DOCKETED	
Docket Number:	19-SPPE-04
Project Title:	SJ2
TN #:	243824-2
Document Title:	Committee Proposed Decision - Part 2
Description:	N/A
Filer:	Ngoc Tran
Organization:	California Energy Commission
Submitter Role:	Committee
Submission Date:	7/1/2022 12:01:57 PM
Docketed Date:	7/1/2022

COMMISSION DECISION

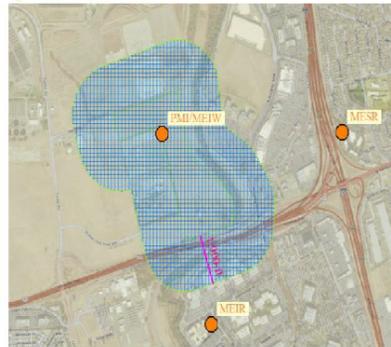
Response: See the above response to Data Request #68.
